ARCHITECTURAL REVIEW BOARD STAFF REPORT

Project #/Name	ARB-2020-44: Schewel Home Sign
Review Type	Certificate of Appropriateness for a Sign
Parcel Identification	04500-00-00-112D0
Location	2020 Seminole Trail
Zoned	Highway Commercial (HC)/Entrance Corridor (EC)
Owner/Applicant	Schewel Charlottesville/Hightech Signs (Kristyn Jones)
Magisterial District	Rio
Proposal	To install a freestanding sign.
Context	The sign is proposed to be located on a parcel that is already developed with the Schewels store. Other commercial developments are located along Rt. 29 to the north and south.
Visibility	The sign will be readily visible from the EC.
ARB Meeting Date	July 20, 2020
Staff Contact	Margaret Maliszewski

Schewel Vertical Monument Sign

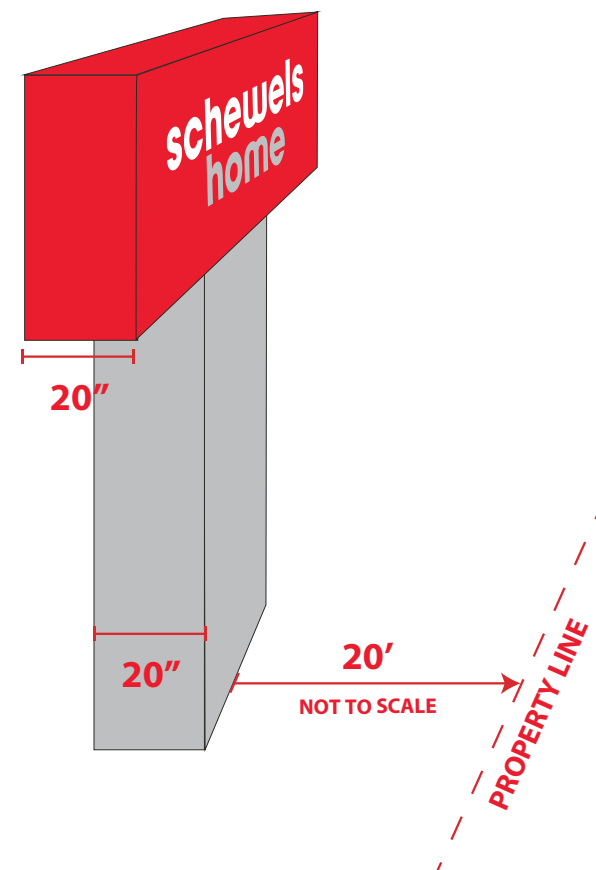
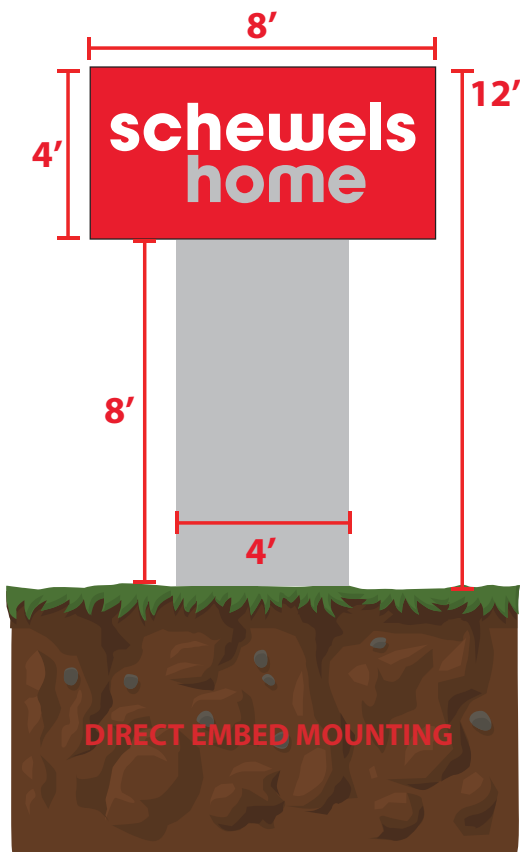
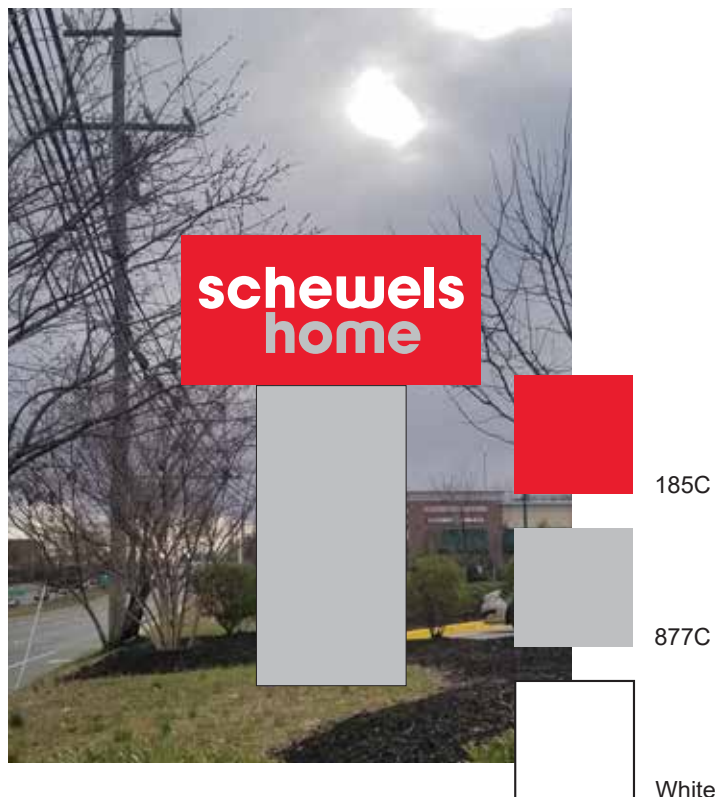
REF	GUIDELINE	ISSUE	RECOMMENDATION
II General Sign Guidelines			
1	Create a consistent and unified design approach along the Entrance Corridors. The <i>placement, size, illumination</i> and <i>colors</i> of signs can create unity along the corridor, or they can create a disjointed, visually competitive environment. Consistent and unified sign design allows the businesses located along the Corridor to have equal standing in visibility. It also provides a pattern of sign placement that makes the business locations and entrances more easily recognizable to both vehicular and pedestrian traffic.	Two signs located to the immediate south of Schewels (Keglers and Rivanna Plaza, Figure 1) are monument style signs consisting of cabinets on brick bases. Other freestanding signs in the vicinity (Atlantic Union Bank, Walmart, Honda/Jeep) also have brick bases. The vertical orientation and metal-panel-covered pole of the Schewels proposal are not consistent with these signs.	Revise the sign design to a monument style with a brick base.

4e	Color: Colors must be harmonious with each other. Colors must not clash with other elements on the site, both when viewed in daylight and at night, whether the signs are externally or internally lit. Overly intense color, such as but not limited to dayglo or fluorescent colors, are prohibited. The use of three colors or fewer is more appropriate for signs in the Entrance Corridor. Black and white are counted as colors. Additional colors may be approved if they contribute to a balanced and unified sign design. For raceway-mounted channel letters, raceways shall match the wall color.	Three colors are proposed: Pantone red 185 for the cabinet, grey 877 for the pole cover and “home” letters, and white for the “Schewels” letters. Generally, red, grey and white are harmonious colors. However, red 185 does not fall within the range of colors typically recommended for approval. Red 187, a darker shade of red, has been approved for other signs in the Entrance Corridors. The face of the sign cabinet is aluminum, so the red background will not illuminate.	Revise the cabinet background color from red 185 to red 187.

REF	GUIDELINE	ISSUE	RECOMMENDATION
	from the top, bottom, sides or back. If outlines of letters are proposed, the width of the outline must be in proportion to the width of the letter. An outline width of 1/8" has been found to be an appropriate dimension for signs in the Entrance Corridors.		
5g	All Illumination shall be non-blinking.	Blinking lights are not proposed.	None.
III Guidelines for Specific Sign Types			
8	Freestanding Signs		
8a	Monument signs are preferred to pole-mounted signs because they are often of a smaller scale and can be more fully integrated into the overall development. Pole signs may be considered for approval if existing site conditions rule out the ability to use a monument sign, and only when the pole is in proportion to the sign cabinet or panel.	The proposed sign has a steel pole at its core, but the pole is not visible because it is hidden by the sign cabinet and the pole cover. The vertical orientation of the sign sets it apart from monument style signs.	Revise the sign design to a monument style with a brick base.

1. Revise the cabinet background color from red 185 to red 187.
2. Revise the sign design to a monument style with a brick base.

Schewel Vertical Monument Sign

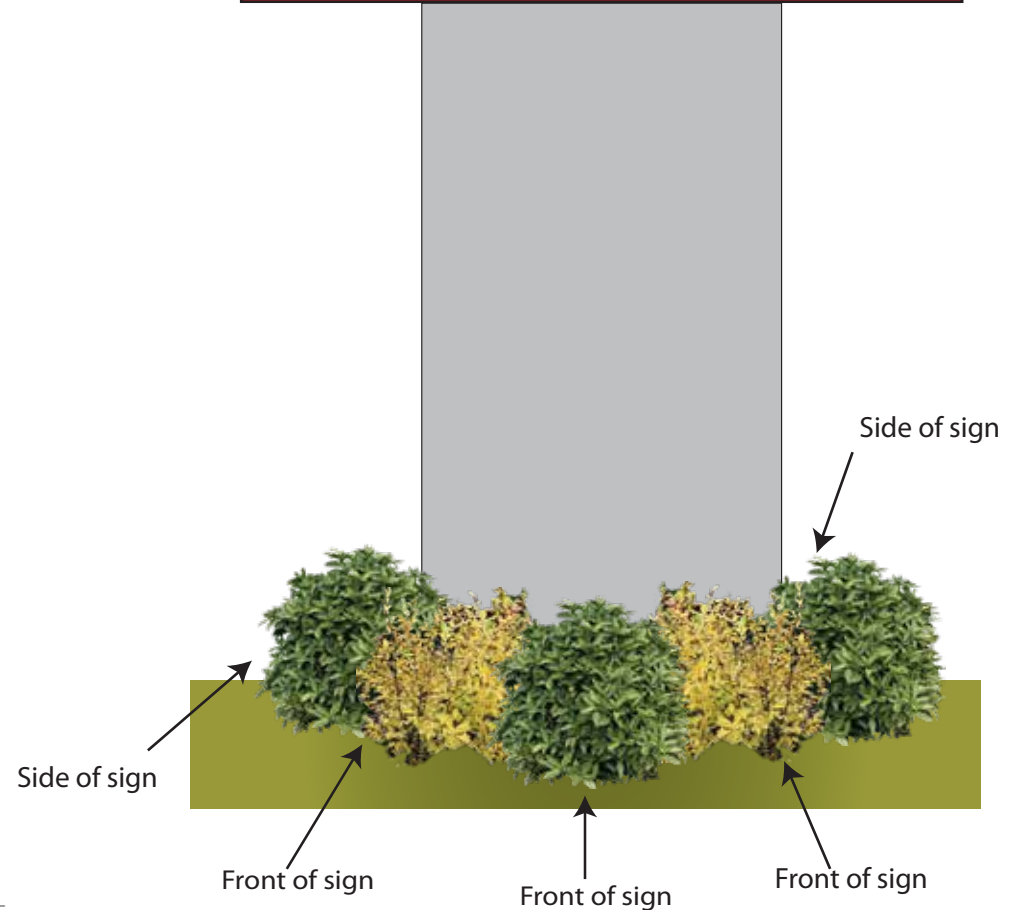
8c	The structure of a monument sign shall not overwhelm the sign. The structure and the sign that it supports must be in proportion to each other.	The sign cabinet and pole cover have the same dimensions. The base does not overwhelm the cabinet.	None.
8d	Landscaping: Use ground cover, shrubs and/or trees to integrate freestanding signs into the overall landscape development of the site. Refer to the Albemarle County Recommended Plants List, which is included in the <i>Albemarle County Architectural Review Board Design Guidelines</i> and is available on-line at www.albemarle.org .	The area between the parking lot and the street already contains landscaping (Figures 3 and 4). Shamrock holly align the perimeter of the parking lot. Locust trees and Crape myrtles are distributed throughout the grassy area. The sign is proposed to be located between a Locust tree and a Crape myrtle tree at the northern end of the parking row that is closest to the street. Alternating shrubs (Japanese Aucuba and Vernal Witch hazel) are proposed to be added at the base of the sign.	None.
